Staff Report for Item 3

Application Number: H16-03-0015

Address: #820 Carsten Lane

Description of Work:

1912 Sanborn Map Overlay

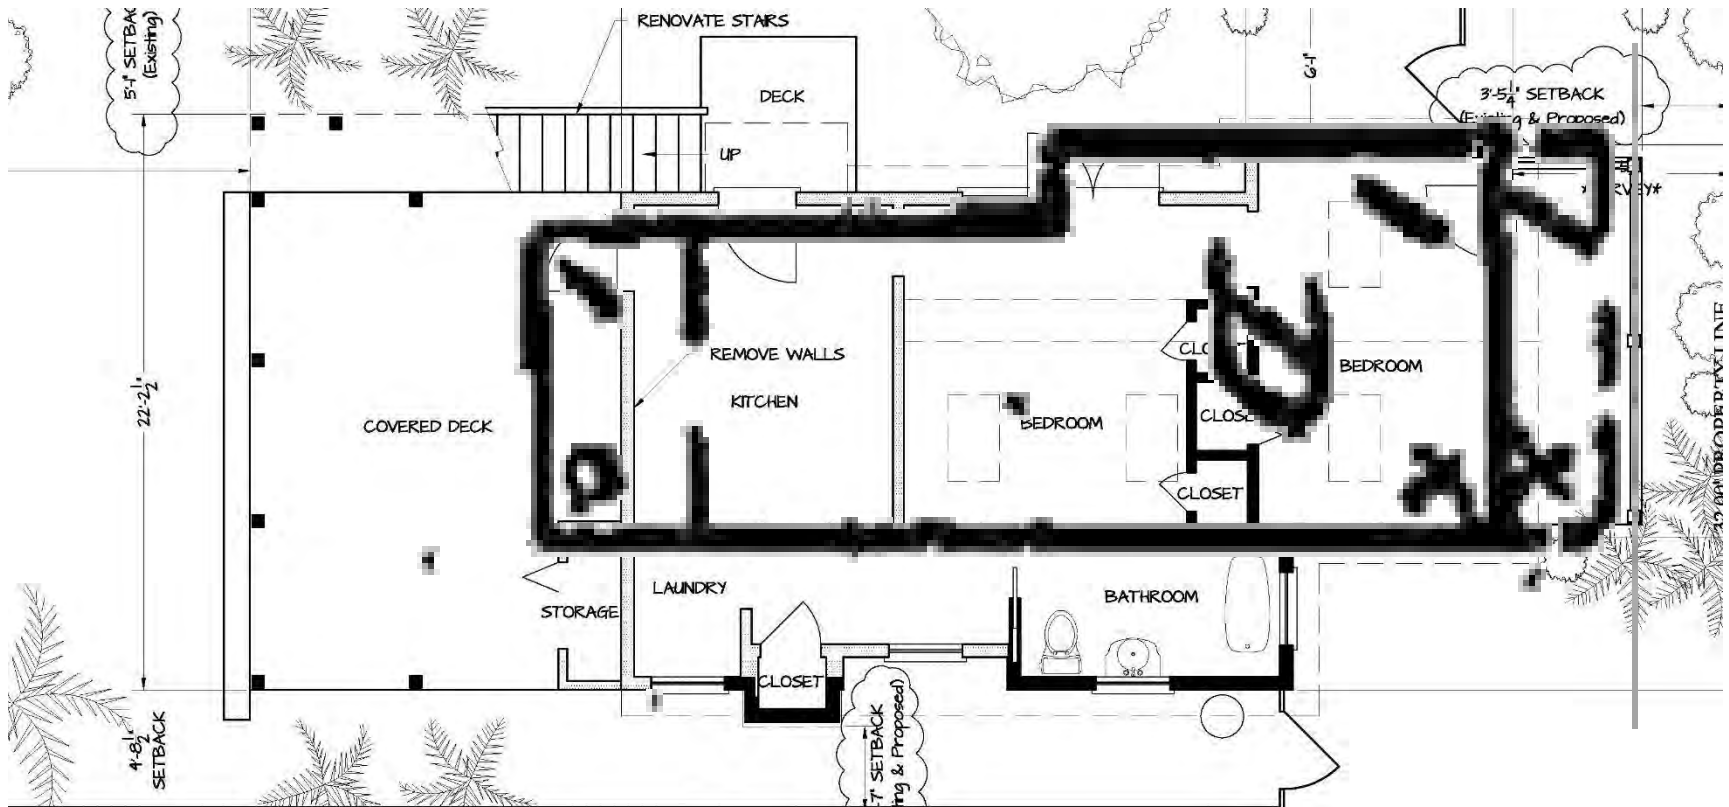
Previously, staff had believed that the rear wall was the rear wall that appears on the Sanborn maps. Staff decided to re-analyze the Sanborn maps and the proportions to the existing building. As can be seen from the overlay of the 1912 Sanborn map and the 1962 Sanborn map, the building used to be longer. It looks like there might have been another addition on the rear built sometime between 1948 and 1962. Staff is now unsure as to whether the rear wall is original to the building, or if it's even historic. The southwestern wall that appears on the Sanborn map, but the type of exterior material (siding) is different from the rest of the building. The roof line differs and the fenestrations are not the original openings that would have existed. The c.1965 photograph shows the building with asbestos siding with vertical boards on the front gable – so no clues as to what the original exterior material was (siding or board and batten). The historic photograph also showed that that house had a small section in the rear with a shed roof, but that roof section is now gone. Because the footprint of the southwest wall appears on the Sanborn maps, staff will consider that wall historic, but is unsure how much historic material is left. Due to the alterations that have happened over time to the southwest wall, staff does not feel that it meets any of the criteria listed in Sec. 102-218, and therefore can be considered for demolition:

Because the historic photograph shows a rear shed roof addition that does not appear to exist anymore and the fact that the existing building is shorter than what the Sanborn maps show, staff is going to consider the rear wall non-historic. Staff believes the demolition of the rear wall, the rear roof on the two-story addition, and staircase will not result in the following items:
